Town of Surfside

RFQ 2022-05

Construction of Town of Surfside 96th Street Park

Addendum No. 4

1 SECOND FLOOR REFLECTED CEILING PLAN
A-1.3 SCALE: 1/4" = 1'-0"

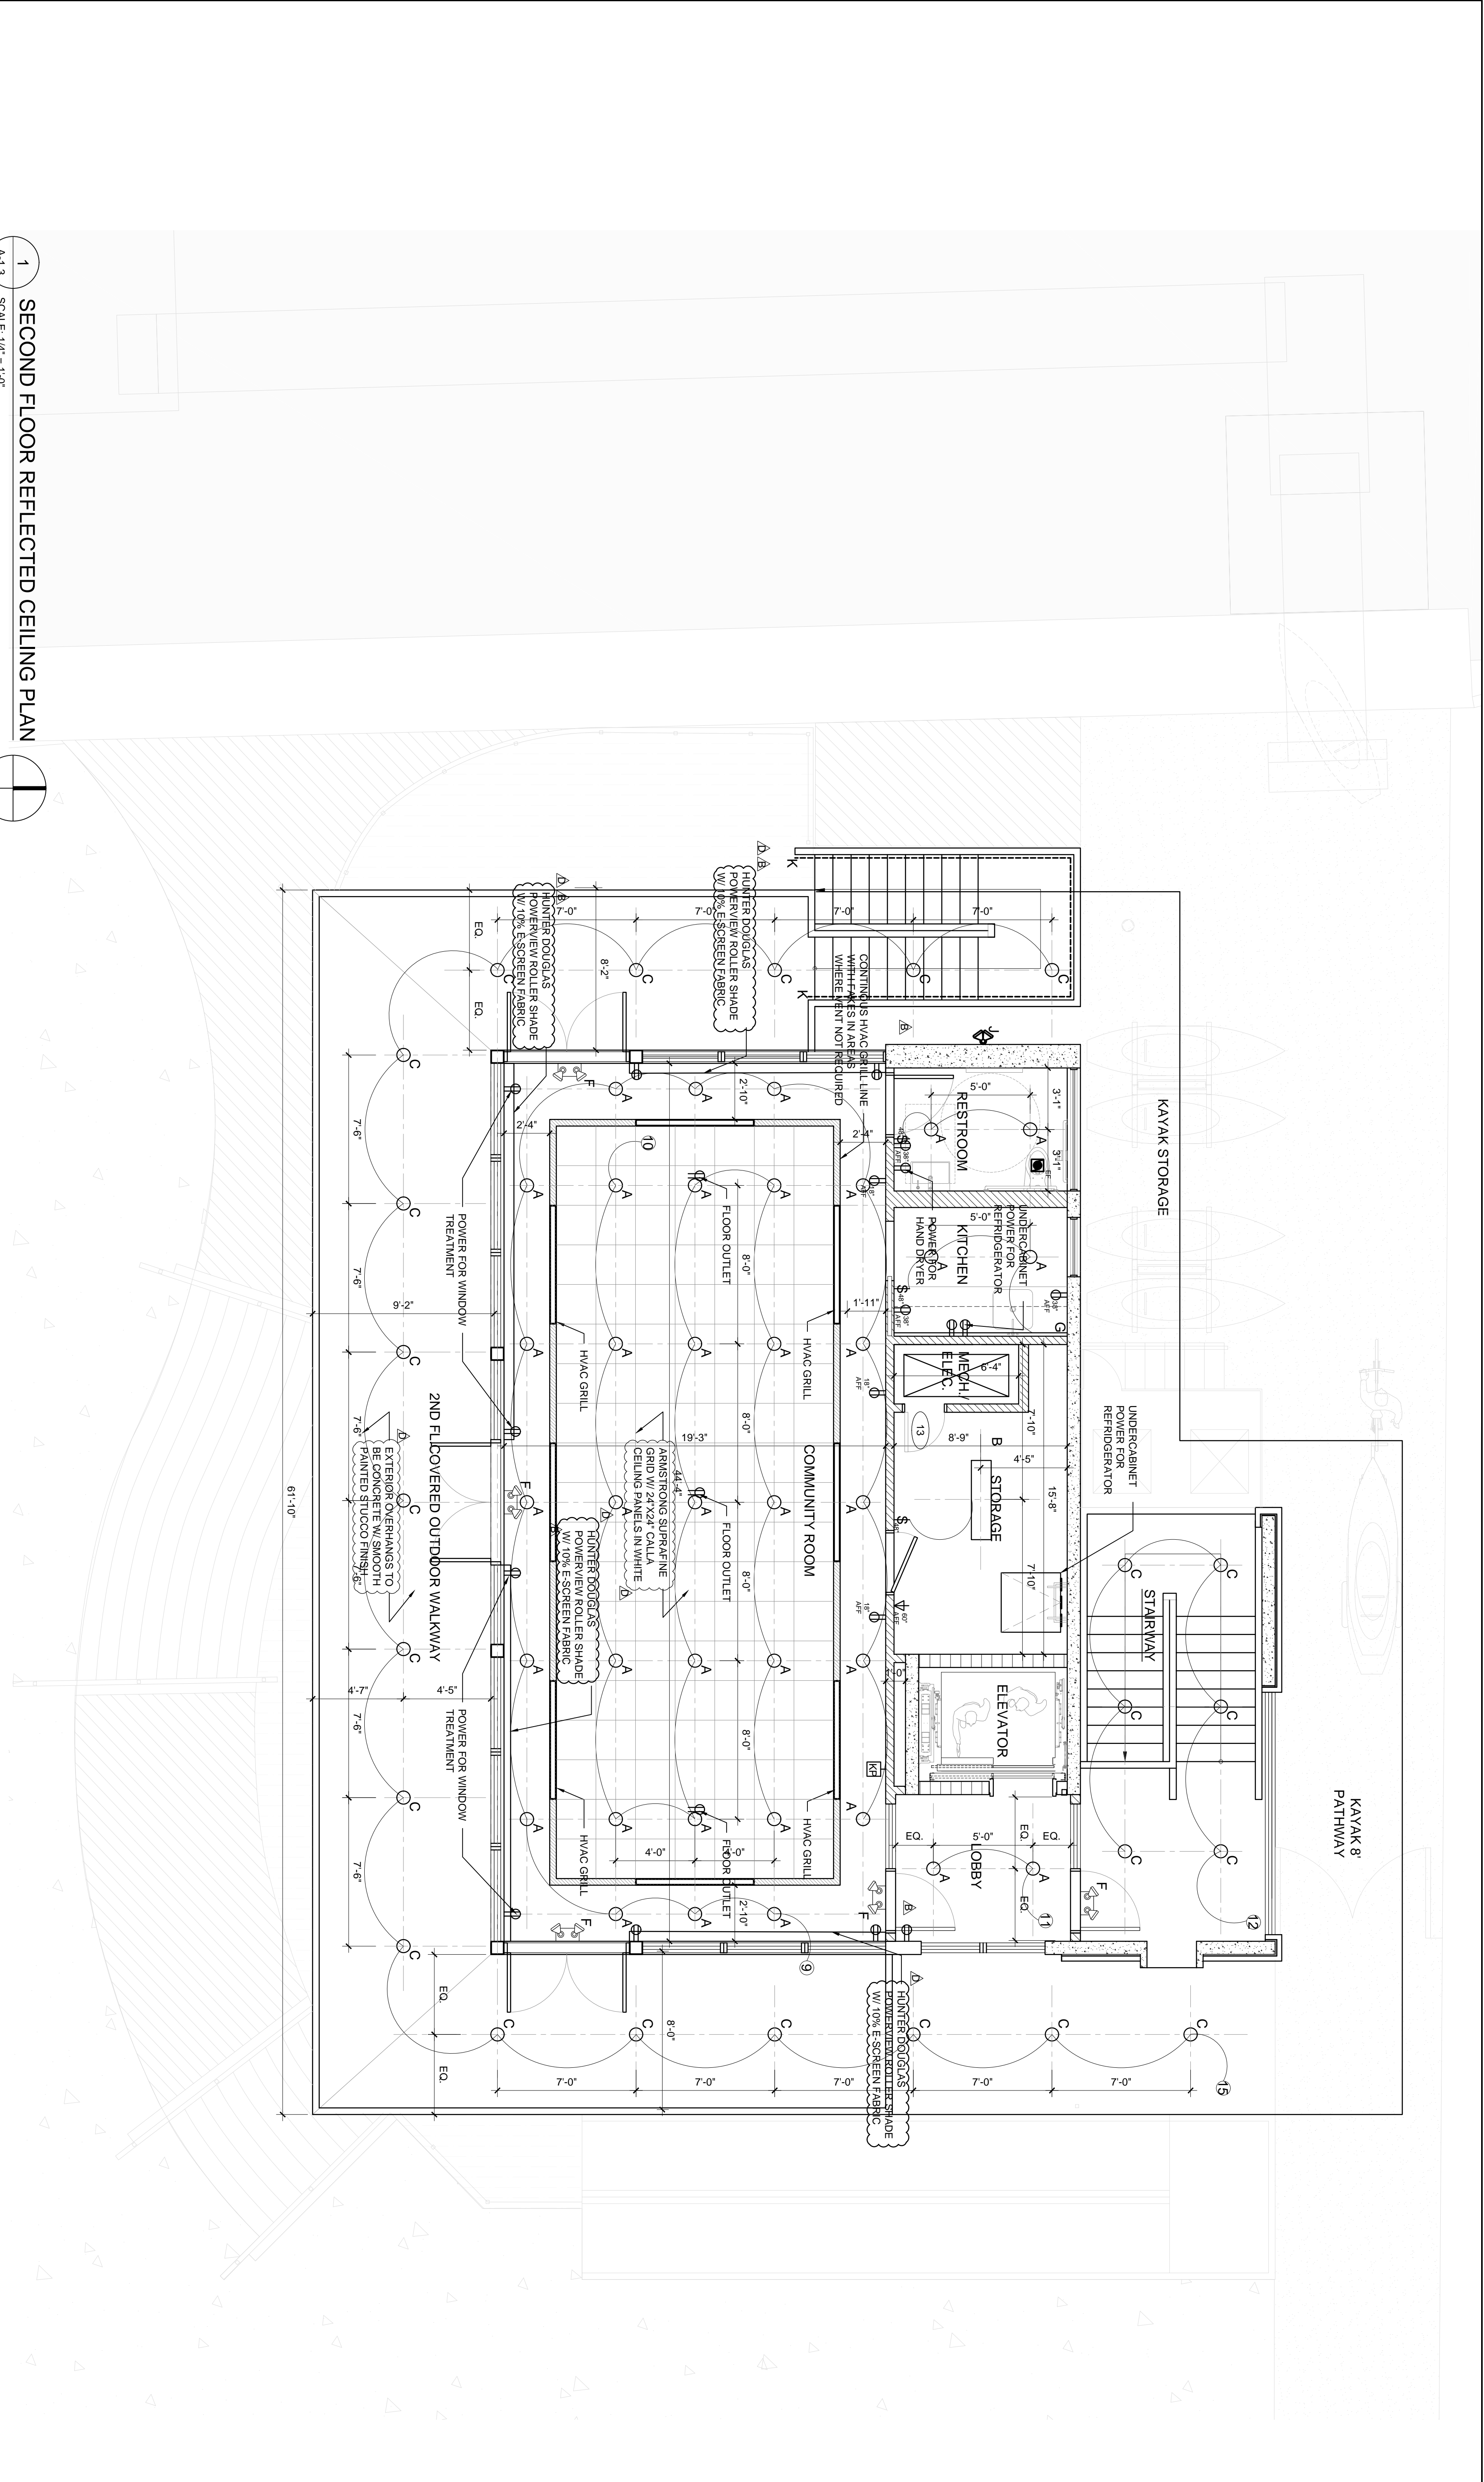
- 36. Project manual includes specifications for motorized window shades (122413 Roller Window Shades) Plans do not indicate locations or electrical provisions. Please clarify.**

- 37. Please provide the specification and details for the proposed Acoustical Ceiling Tile. The Grid is specified, but the Tile is not.**

Refer to sheet 1/A-1.3 second floor reflected ceiling plan and electrical circuit junction boxes shown on sheet E-303, circuit 14.

The ceiling system note on sheet 1/A-1.3 has been updated to reflect the Suprafine grid system to be used with the Calla 24"x24" ceiling panels in white color.

1 ROOF PLAN
A-1.4 SCALE: 1/4" = 1'-0"

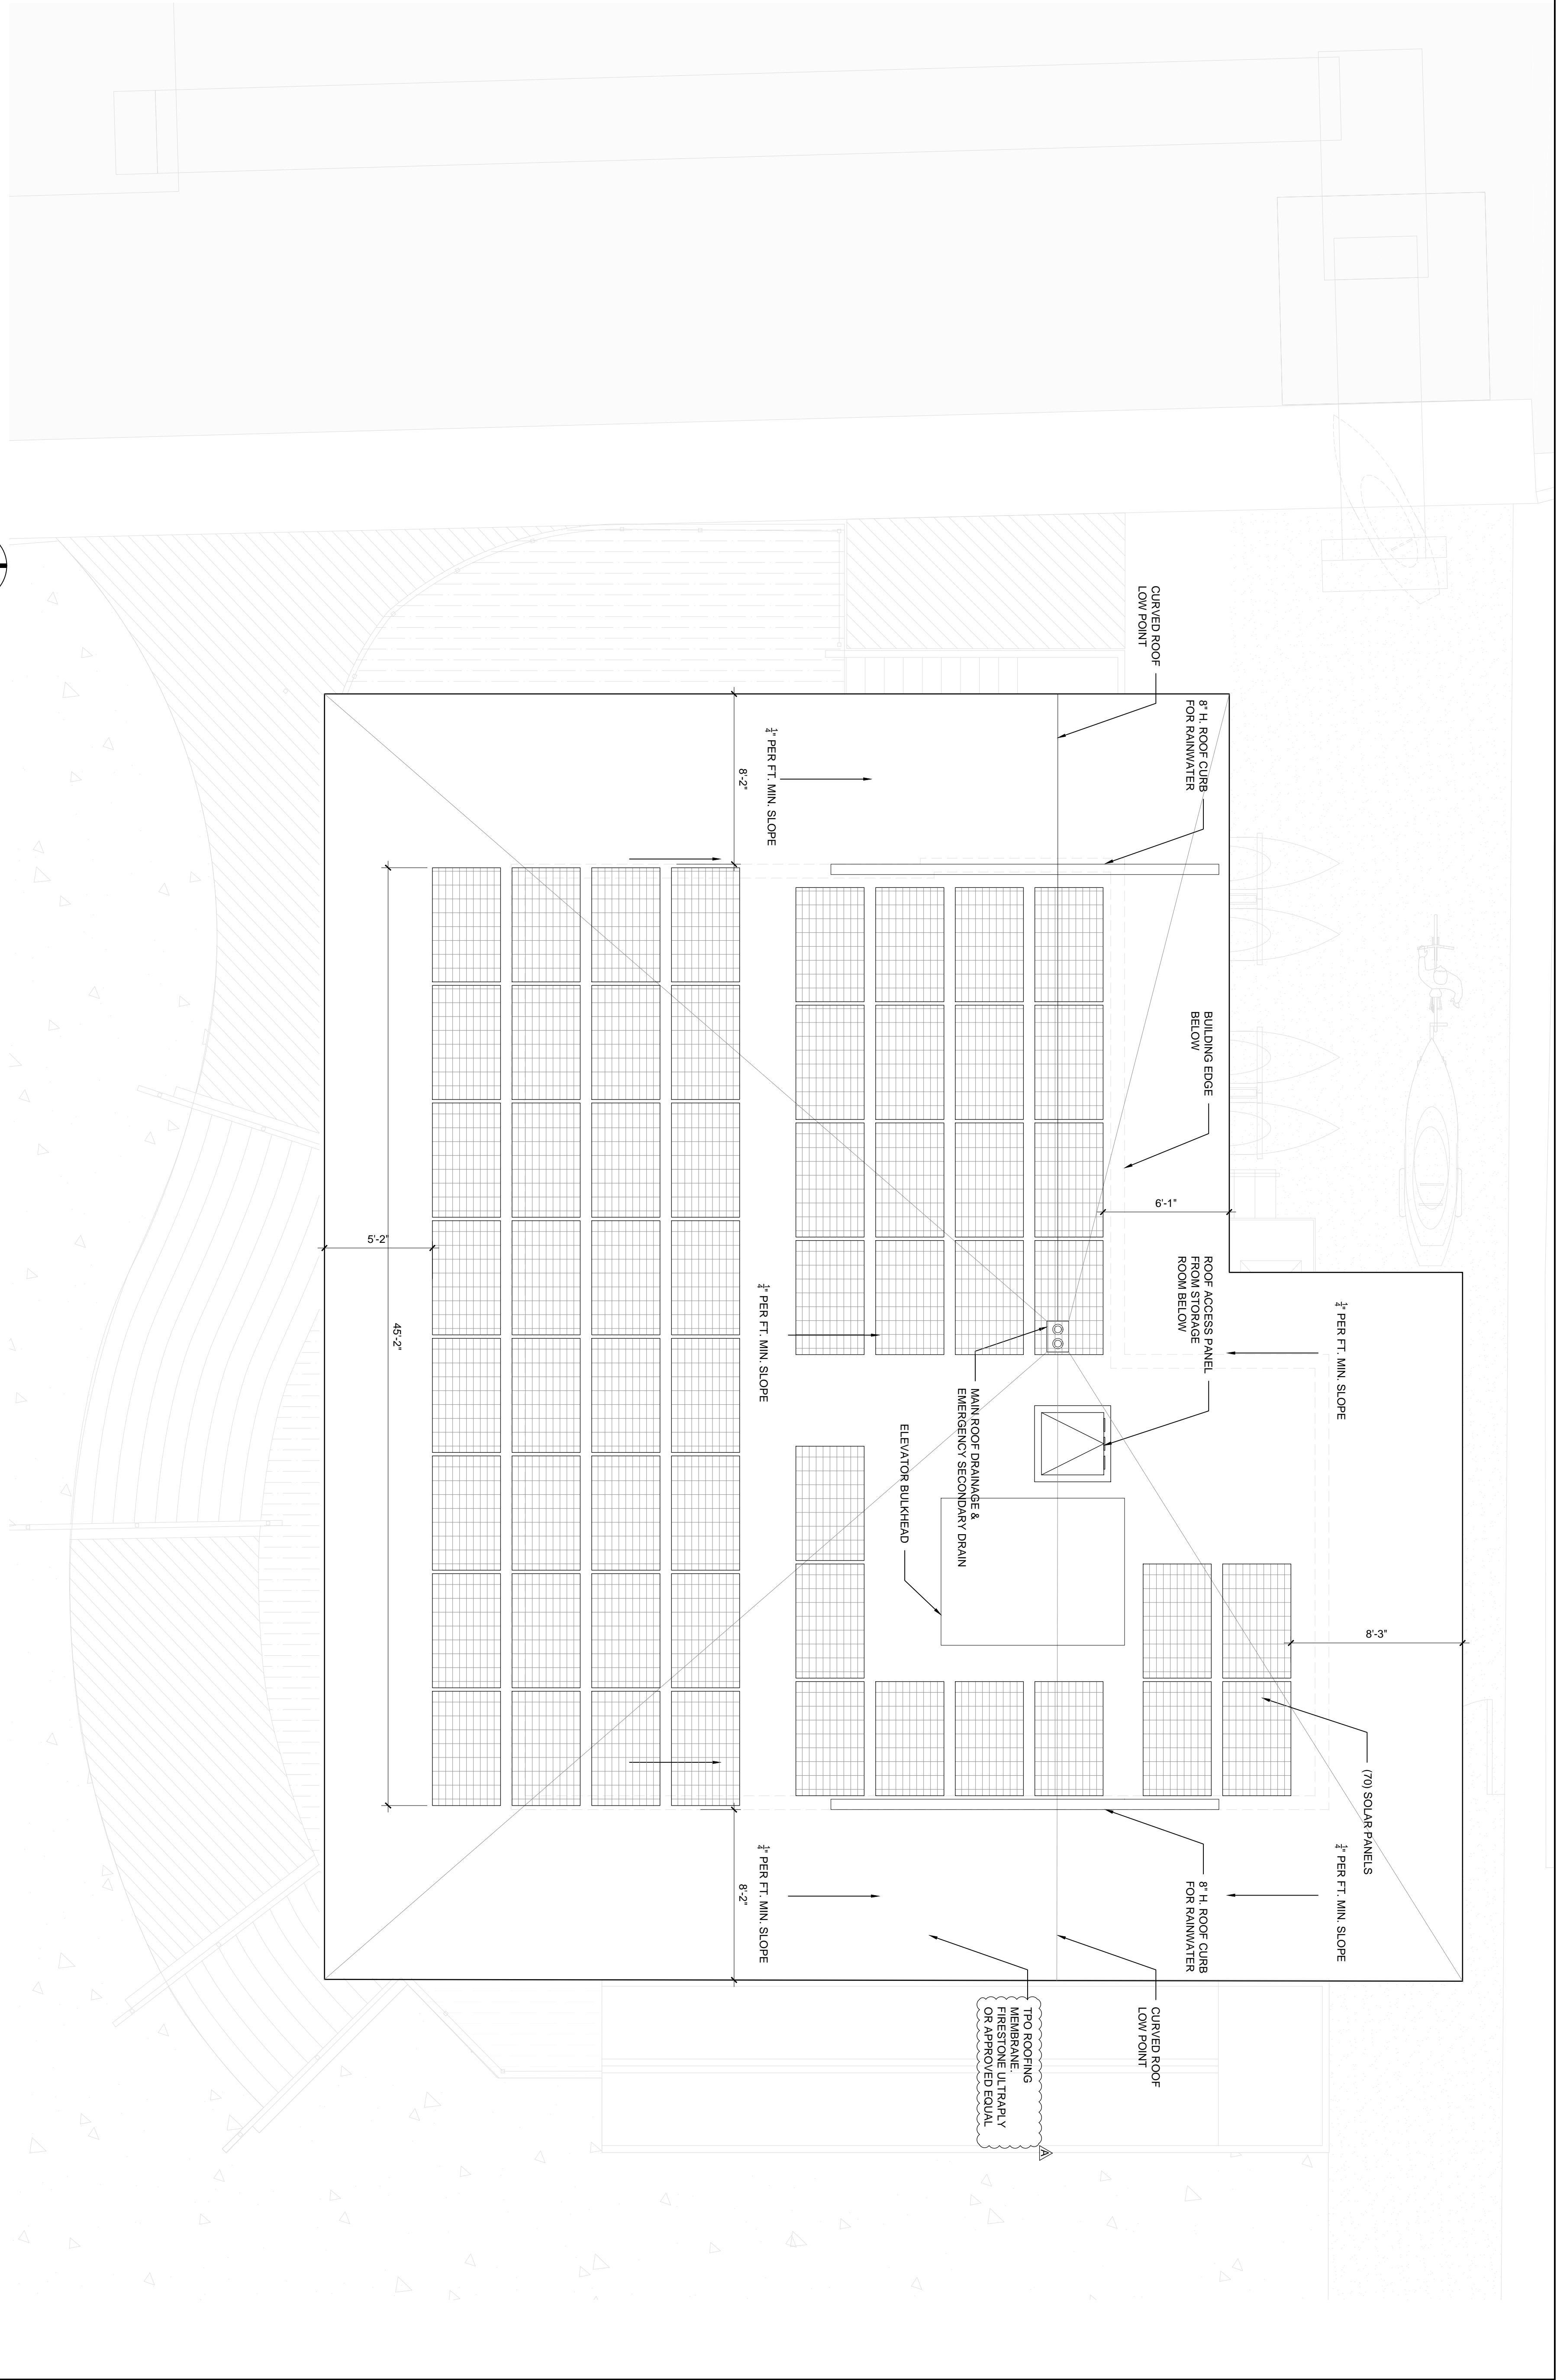
51. Sheet A-1.4 shows a roof access panel; no details or specifications are given. Please provide roof access panel specifications / manufacturer / design.

Bilco E-50HZ -11 Gauge Aluminum Single Leaf Roof Scuttle w/ access ladder specification added to the door schedule on sheet A-6.0.
